Model: Model K-P4	Date: 17-Feb-05	No.: RG116001a
-------------------	-----------------	----------------

Subject: Controller Firmware Release History (System)		Prepared by: A. Ishiyama	
From: 1st Tech. Support Sec. Service Support Dept.			
Classification:	<input type="checkbox"/> Troubleshooting	<input type="checkbox"/> Part information	<input type="checkbox"/> Action required
	<input type="checkbox"/> Mechanical	<input type="checkbox"/> Electrical	<input type="checkbox"/> Service manual revision
	<input type="checkbox"/> Paper path	<input type="checkbox"/> Transmit/receive	<input type="checkbox"/> Retrofit information
	<input checked="" type="checkbox"/> Other (      )

Model: Model K-P4		Date: 25-Mar-05	No.: RG116008
Subject: Right Cover		Prepared by: A. Ishiyama	
From: 1st Tech. Support Sec. Service Support Dept.			
Classification:	<input type="checkbox"/> Troubleshooting	<input type="checkbox"/> Part information	<input type="checkbox"/> Action required
	<input type="checkbox"/> Mechanical	<input type="checkbox"/> Electrical	<input checked="" type="checkbox"/> Service manual revision
	<input type="checkbox"/> Paper path	<input type="checkbox"/> Transmit/receive	<input type="chec

### 3.3.6 EXTERIOR COVERS [G116]

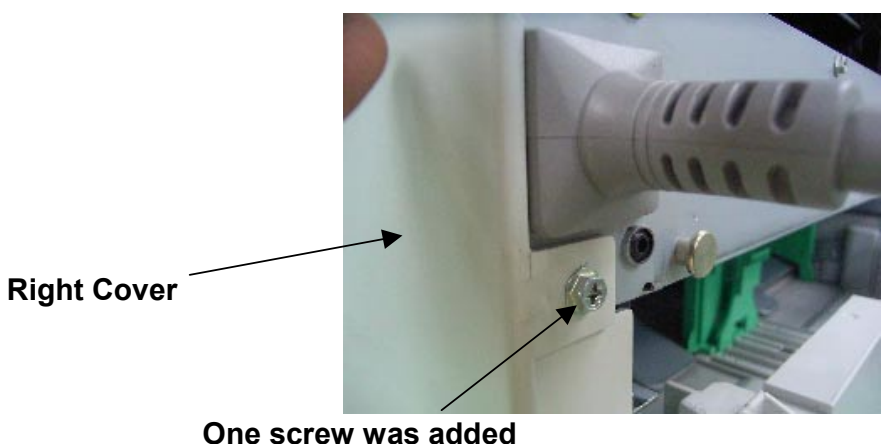
The procedure below was changed from the beginning of mass production:  
 One screw (🔩 x 1) was added to the step for removing the right cover. See the **bold, underlined** area.

- [A]: Left cover (🔩 x 2)
- [B]: Front cover (3 clamps, 2 harnesses)
- [C]: Right cover (3 hooks **and 🔩 x 1**)

## Important Note on the Bypass Feed Mechanism

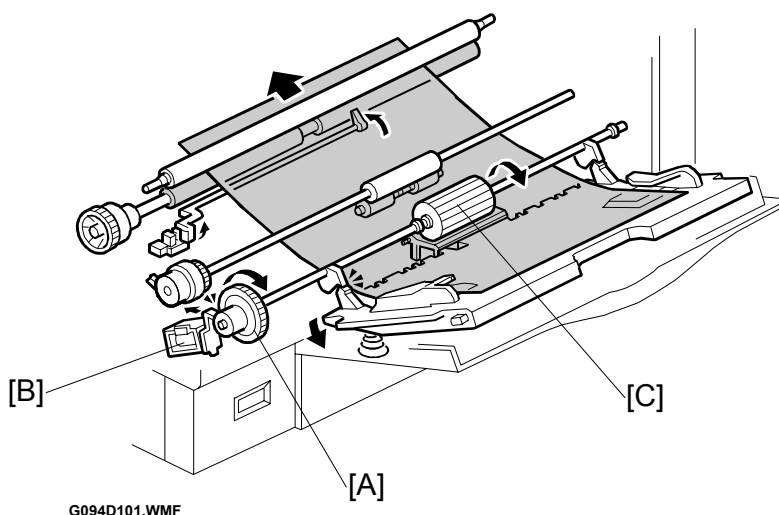
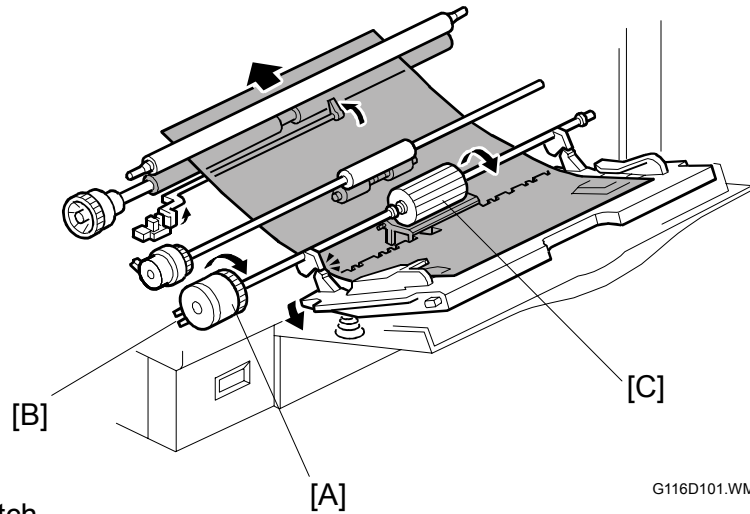
The paper feed mechanism for the bypass tray will be **temporarily** changed from a clutch system to a **solenoid** system. The system will be changed back to the clutch system from around August 2005 production (cut-in S/N TBA).

- This is the same solenoid system that is used on the C-P1/K-P3.
- This change is for the C-P2b/P2c and K-P4.
- See MB MG116005 for the P/N details.
